Service Bulletin

Bulletin No.: PI0974

Subject: A/C Blows Warm Air, A/C Inoperative, Automatic Transmission Cooler Bracket Contacting Condenser

Models: 2012-2013 Chevrolet Impala (Police Vehicle)
Equipped with 9C1 or 9C3

3420713

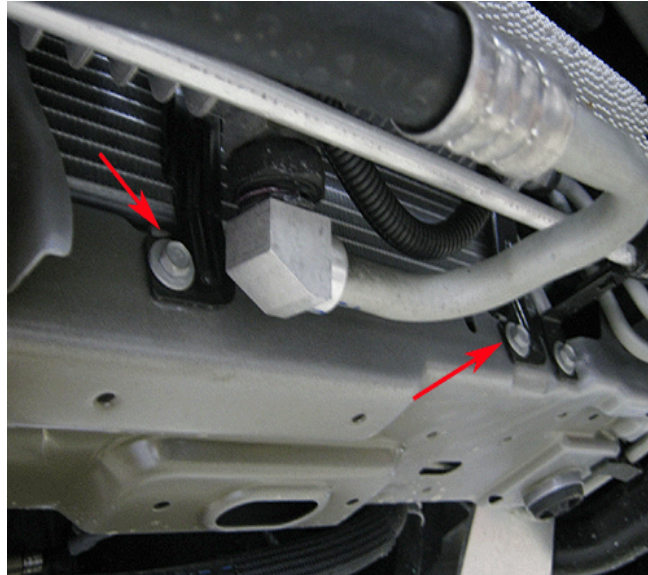
Some customers may comment that the A/C blows warm or is inoperative.

This may be caused by the transmission oil cooler bracket contacting the A/C condenser and rubbing through, resulting in a refrigerant leak.

Replace the condenser and adjust the automatic transmission oil cooler brackets (reposition at locations shown and/or install 1/8" shims) for clearance away from the A/C condenser. Refer to Air Conditioning Condenser Replacement in SI.
